**ADDENDUM NO. 02**

**DATE: 08/04/2023**

Clark/Mercedes Edwards Theater Remodel Phase 2  
Clovis, CA 93612  
Client Bid No: 2960

DARDEN PROJECT NO. 2215  
DSA File Nos. 10-27  
DSA APPL. NO. 02-121097

1  
X/S703  
1" = 1'-0"

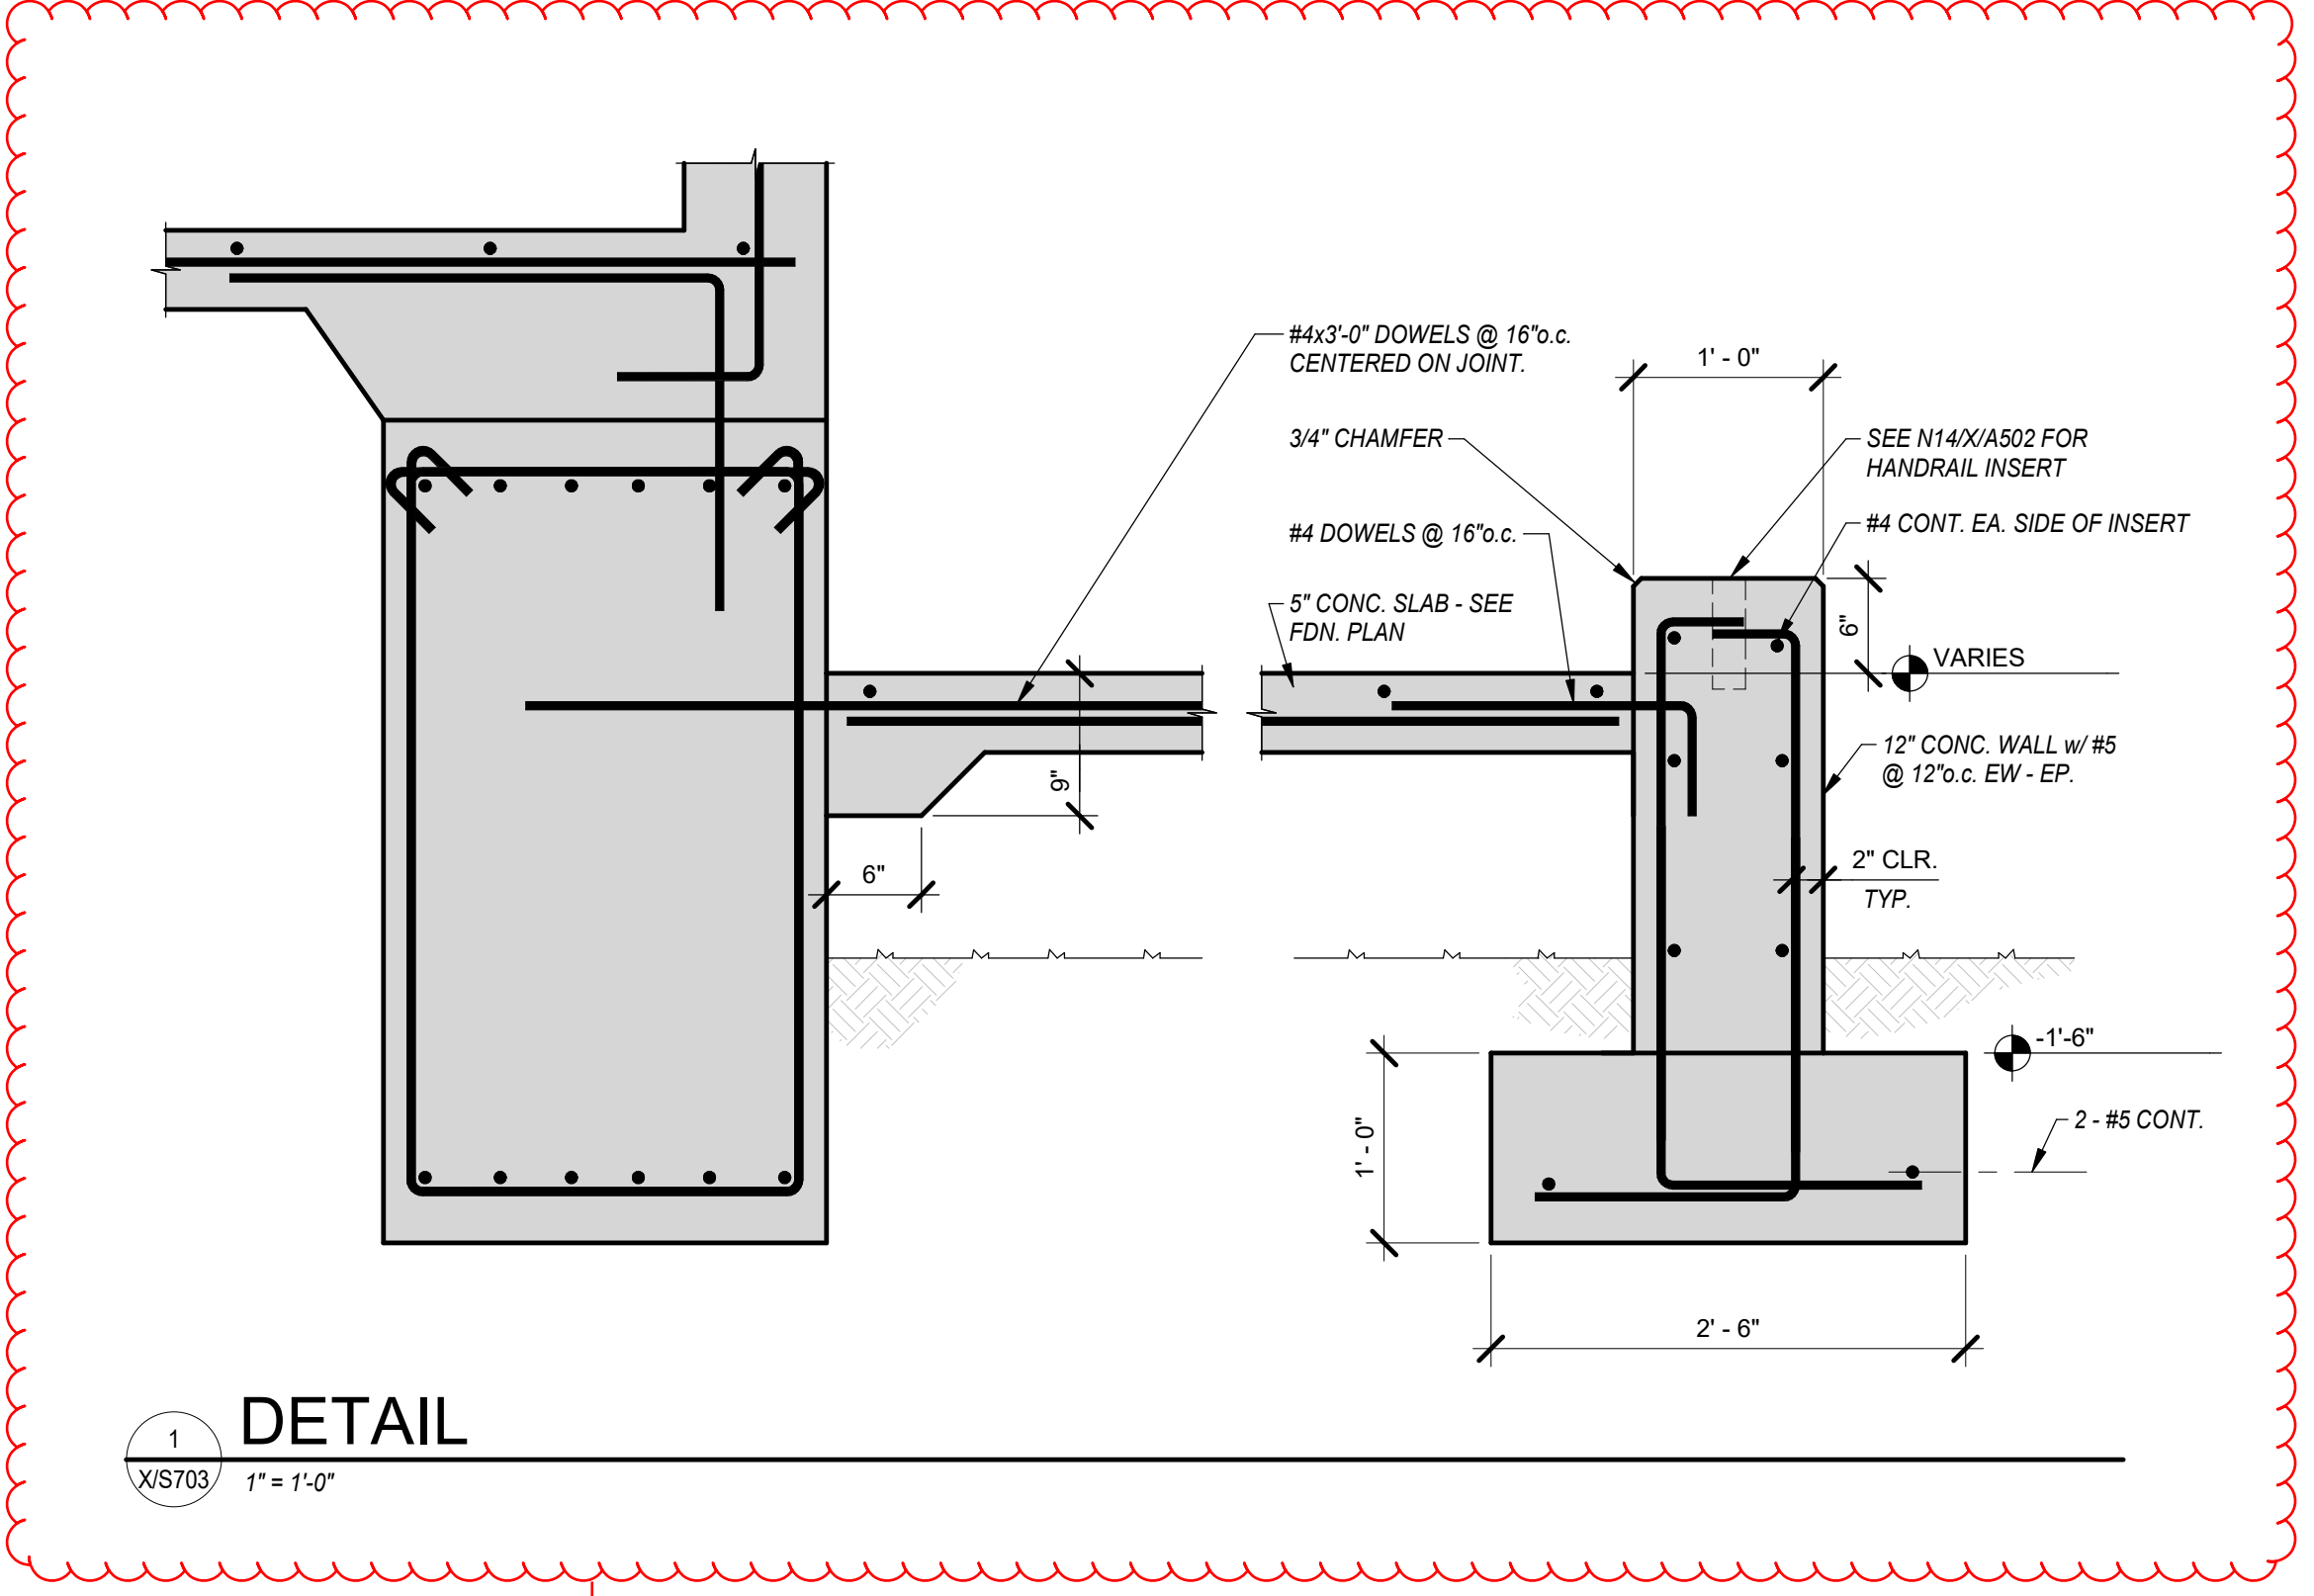
- AD02-S05 Refer to Sheet X/S703:**
1. Remove and replace with attached sheet AD02-SX05. Details 1 and 2 were revised to coordinate the size of the ramp curb and foundation with the architectural drawings.

Copyright 2022 Darden Architects  
 X/FS800  
 AD02-FSX02

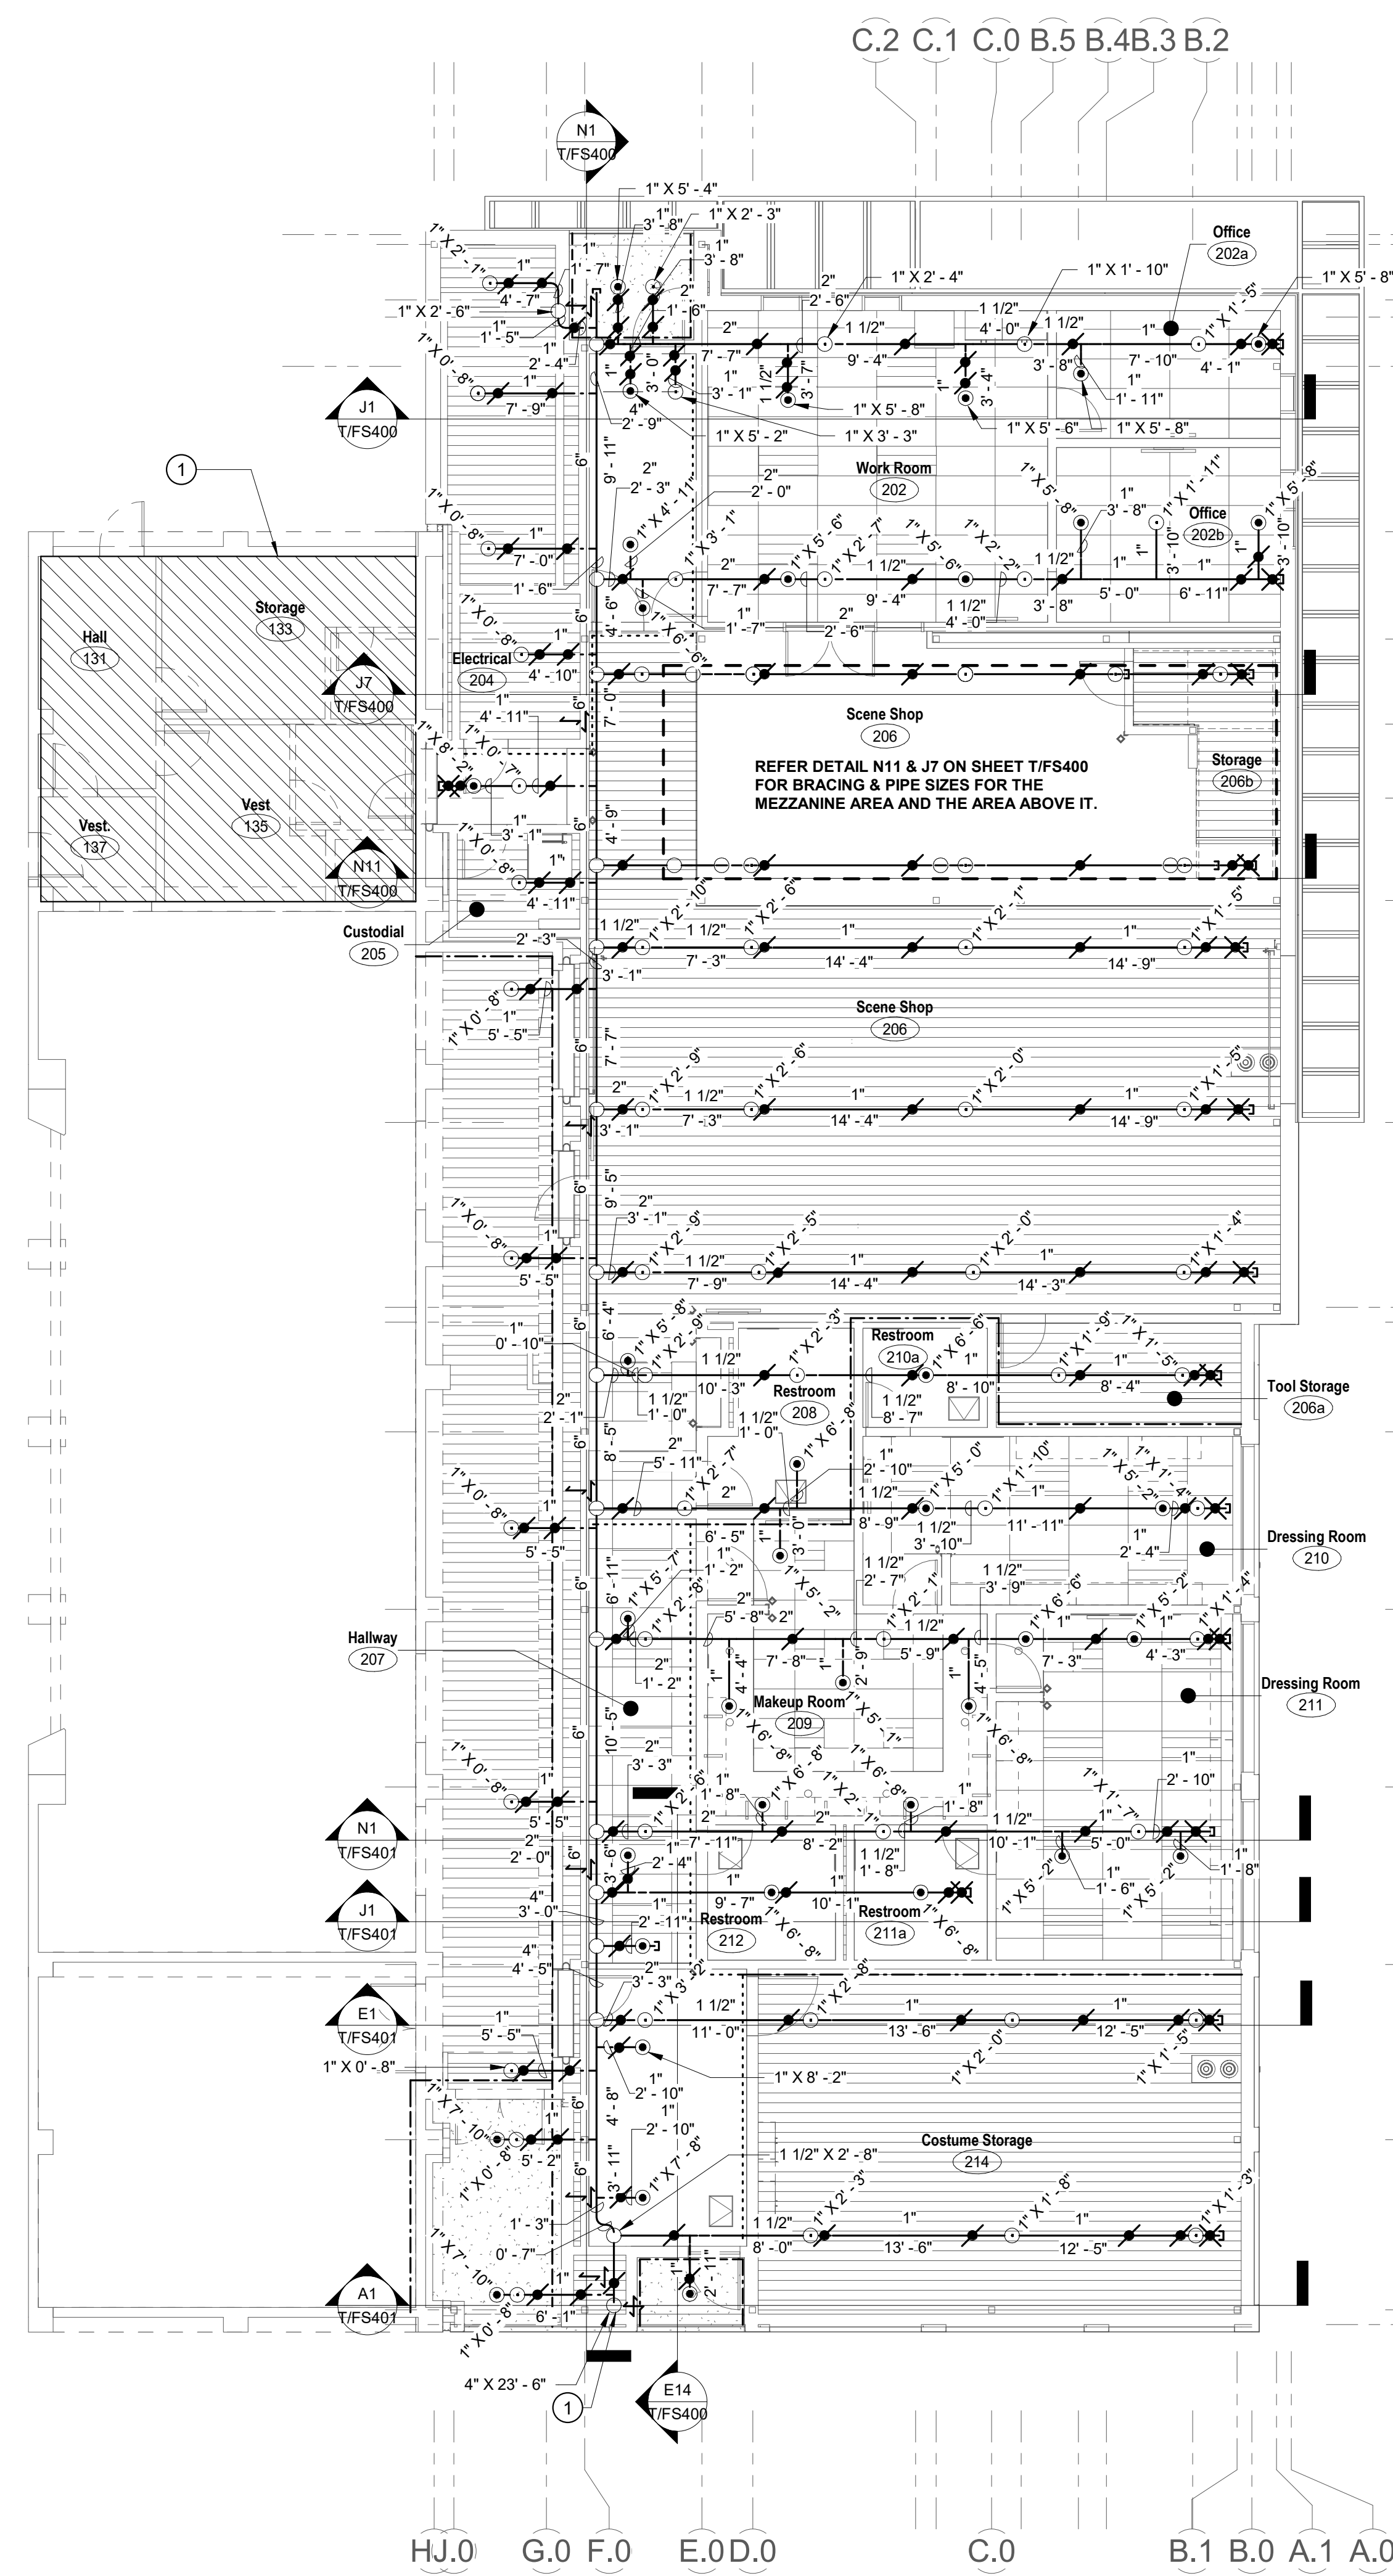
- AD02-FS01 Refer to Sheet SD/FS001:**
1. Remove and replace with attached sheet AD02-FSX01
- AD02-FS02 Refer to Sheet X/FS800:**
1. Remove and replace with attached sheet AD02-FSX02
- AD02-FS03 Refer to Sheet X/FS801:**
1. Remove and replace with attached sheet AD02-FSX03
- AD02-FS04 Refer to Sheet T/FS100:**
1. Remove and replace with attached sheet AD02-FSX04
- AD02-FS05 Refer to Sheet T/FS101:**
1. Remove and replace with attached sheet AD02-FSX05
- AD02-FS06 Refer to Sheet T/FS102:**
1. Remove and replace with attached sheet AD02-FSX06
